## Economic Commission for Europe

Working Party on the Transport of Perishable Foodstuffs

**Proposals of amendments to ATP:**

### **Definition of the independence of equipment taking into account mixed energy source technologies**

## Autonomie d'un engin - Exemple

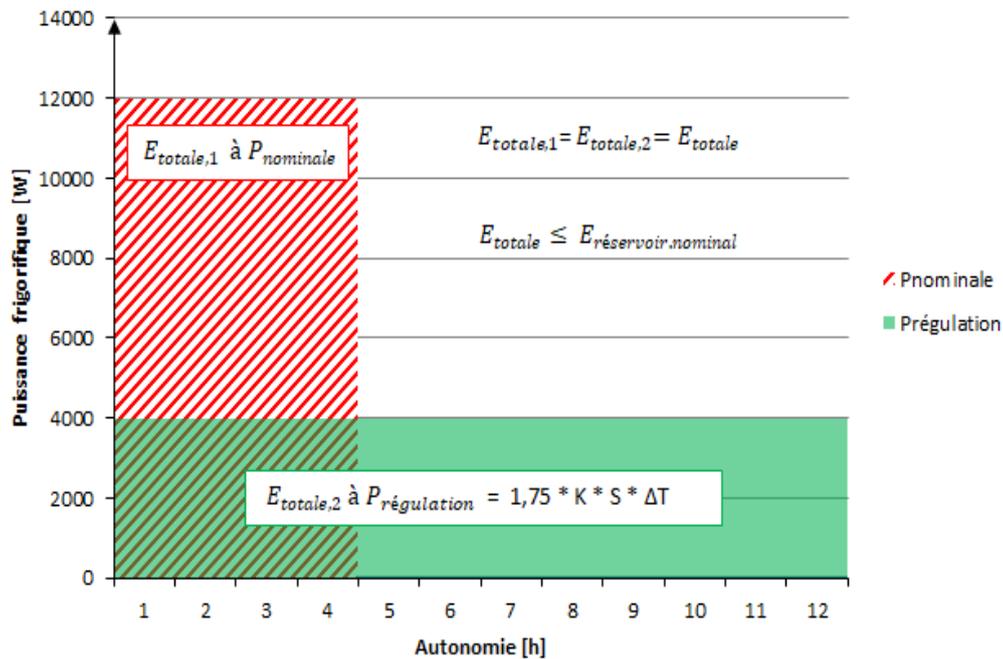
Negligible recharging time is deemed to be any operation lasting less than 20 minutes that allows for the recharging of the energy reservoir to its maximum starting with no more than one quarter of its nominal capacity.

The equipment must satisfy the following requirement:

$$t_0: E_{tank,t_0} \leq \frac{1}{4} * E_{nominal.tank}$$

$$t_1: E_{tank,t_1} = E_{nominal.tank}$$

$$\Delta t = t_1 - t_0 < 20$$

### Autonomie d'un engin - Exemple

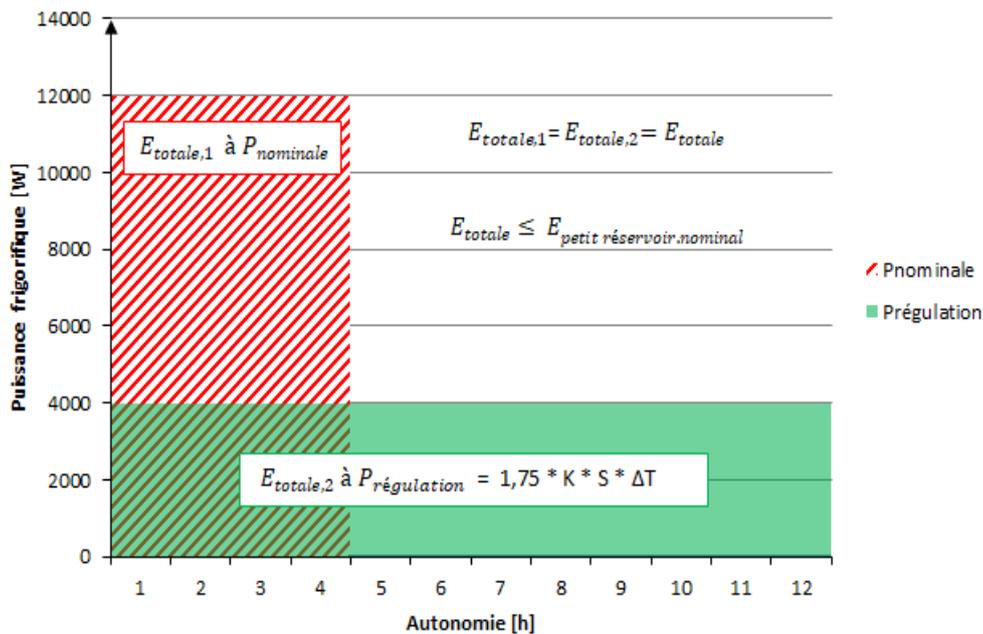
Negligible recharging time is considered to be any operation that makes it possible, in less than three quarters of an hour, to increase the energy equal to at least half of the maximum energy capacity that can be stored in the energy reservoir in question.

The equipment must satisfy the following requirement:

$$t_0: 0 \leq E_{tank,t_0} \leq \frac{1}{2} * E_{nominal.tank}$$

$$t_1: E_{tank,t_1} \geq E_{tank,t_0} + \frac{1}{2} * E_{nominal.tank}$$

$$\Delta t = t_1 - t_0 < 45$$
